# PARTS & SERVICE NEWS

REF NO.	AT03125
DATE	Jul. 10, 2003

**SUBJECT:** REPAIR PROCEDURE OF REAR COVER BRACKET IN CAB ON HD465-7, HD605-7

**PURPOSE:** To introduce modification procedure to repair the rear cover mounting bracket positioned inside the operator's cab on HD465-7 and HD605-7 dump trucks

Details drawing of the section "P"

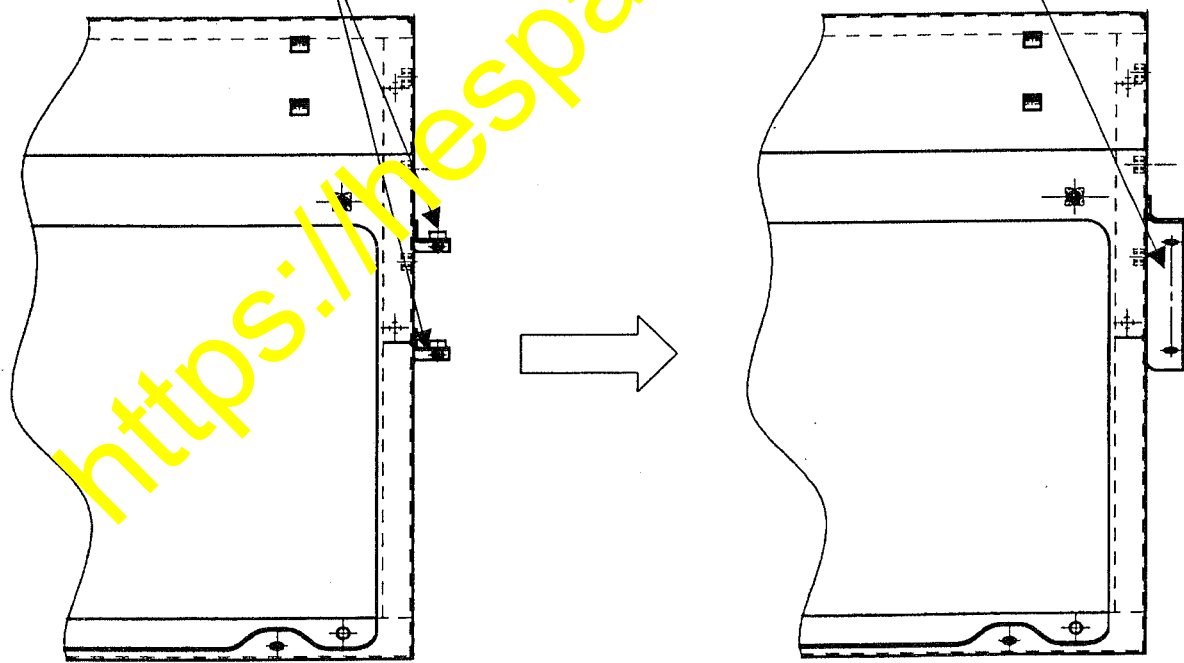
The rear cover mounting bracket positioned inside the operator's cab is to be modified as indicated below to reinforce its structure.

- ① L-shaped plates in 2 pieces → L-shaped plate of a solid structure
- ② Sheet thickness: t 2.3 → t 3.2

Fig. 1: Bracket

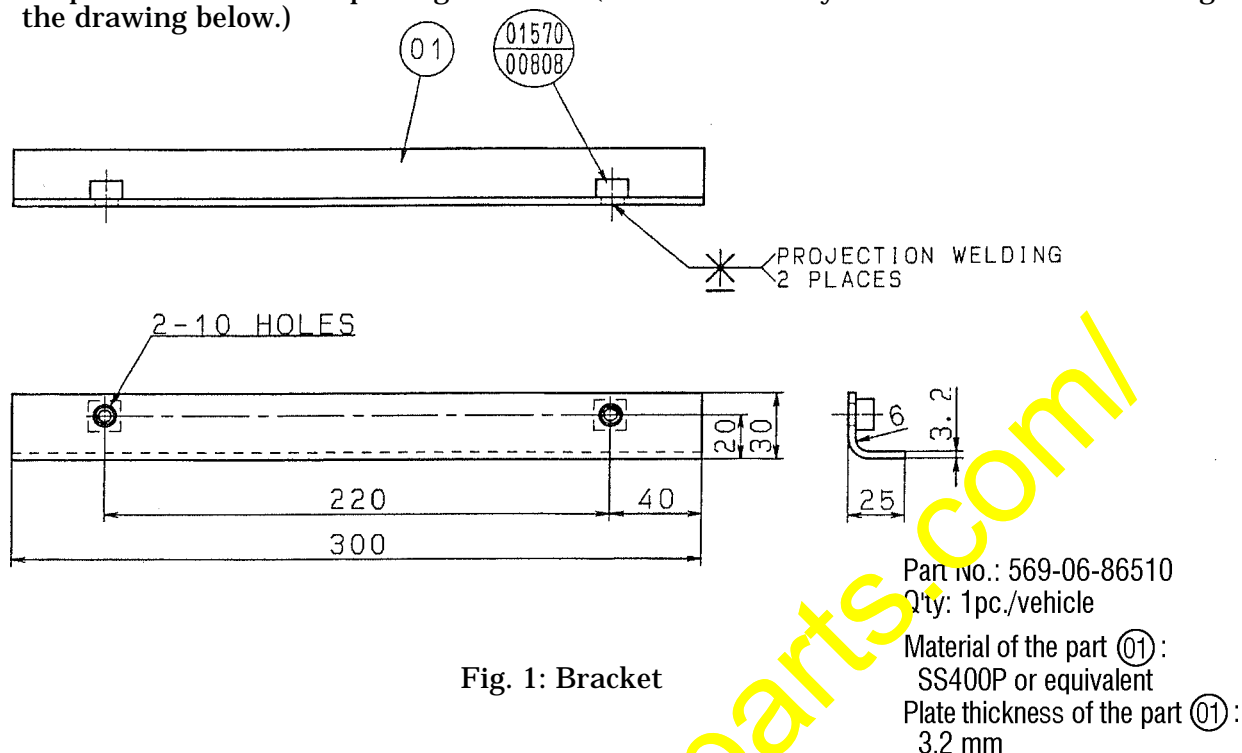
Prepare the bracket as per Fig. 1 below. (The bracket may also be made out referring to the drawing below.)

Fig. 2: Removal drawing

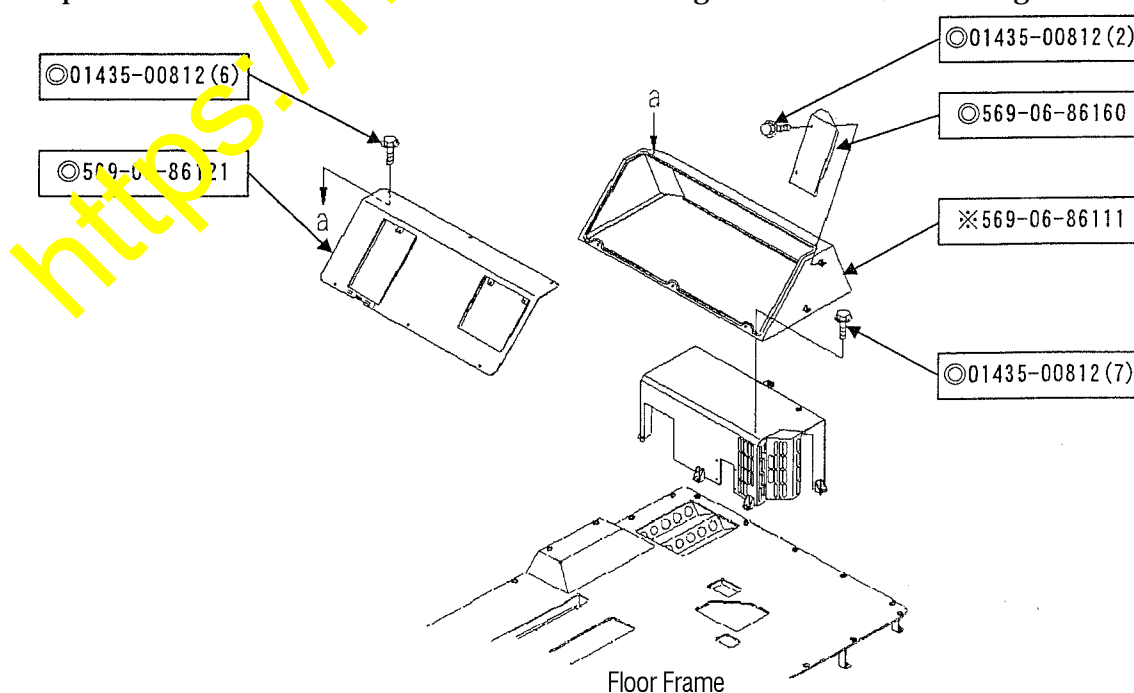
Remove the parts marked ① and ※ (Refer to Fig. 2.)

Since the parts marked ① are being reused at the reassembly of the modified parts, store them carefully.

The parts marked ※ are to be reused after finishing the additional working.

Fig. 3: Additional working drawing 1

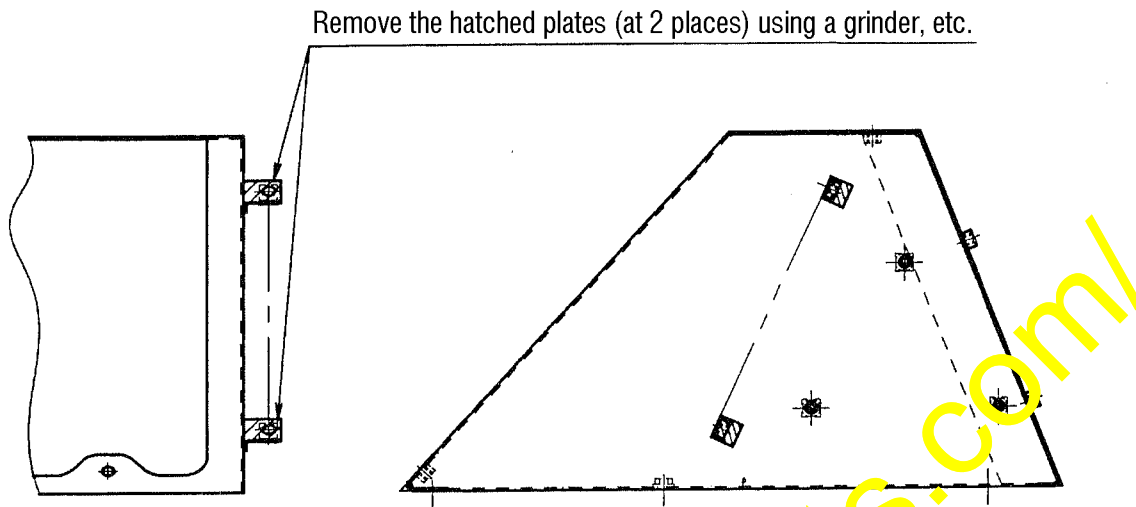
Make additional working to the bracket (569-06-86111) which has been removed as per the instructions given in Section 4-3, following the instructions given in Fig. 3 and Fig. 4 indicated below.

Fig. 4: Additional working drawing 2

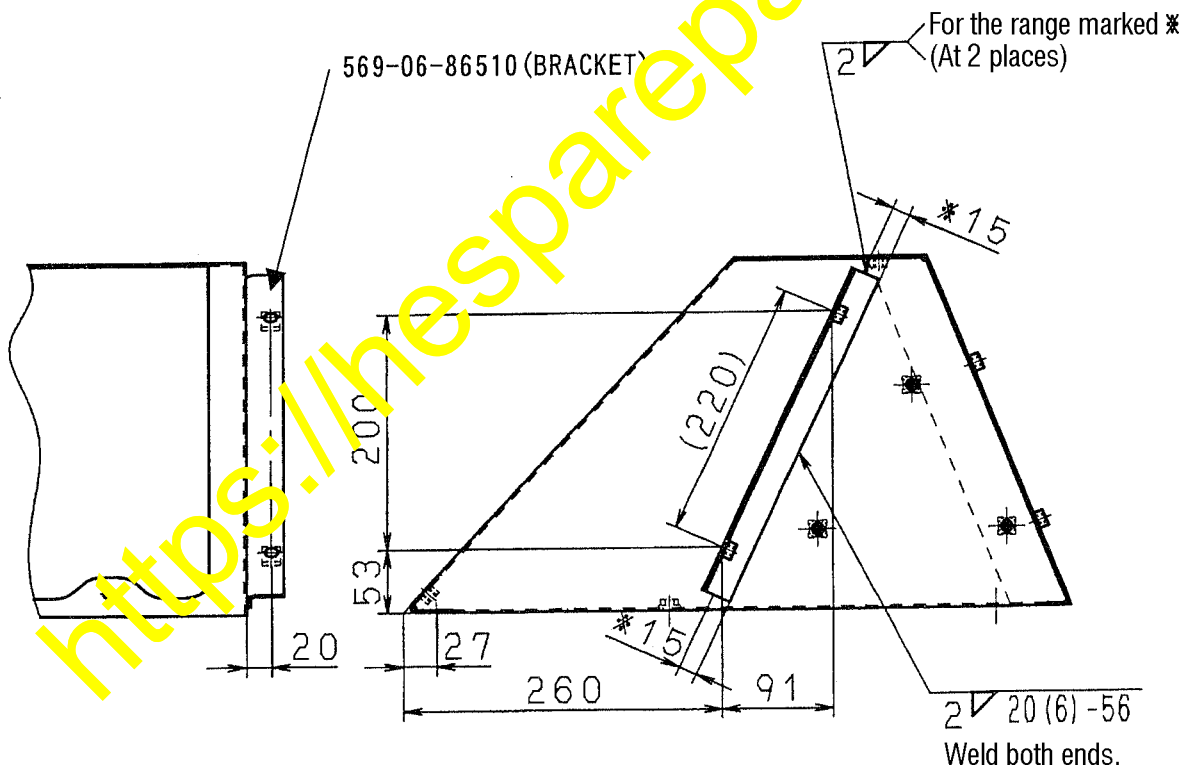
After completing the welding work, paint the welded section with the Cab Gray color paint.
